Access Compliance Report Public Rights-of-Way (Pedestrian Signals)

Main Street: **LAMBERT_RD** Cross Street: **VALENCIA_AVE** Location: **NW**

ADA ID: **SGAT210920095612** Signal Type: **One Push Button-APS** Overall Compliance: **No** Severity Scores: **BTN 1: 25 BTN 2: N/A No BTN: N/A**

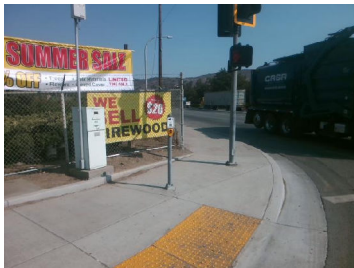
OC Std/PROW: MUTCD 4e.08, R404.2, R404.3

Possible Solutions: Replace Signal Push Button With APS Button. Remove & Relocate Sign.
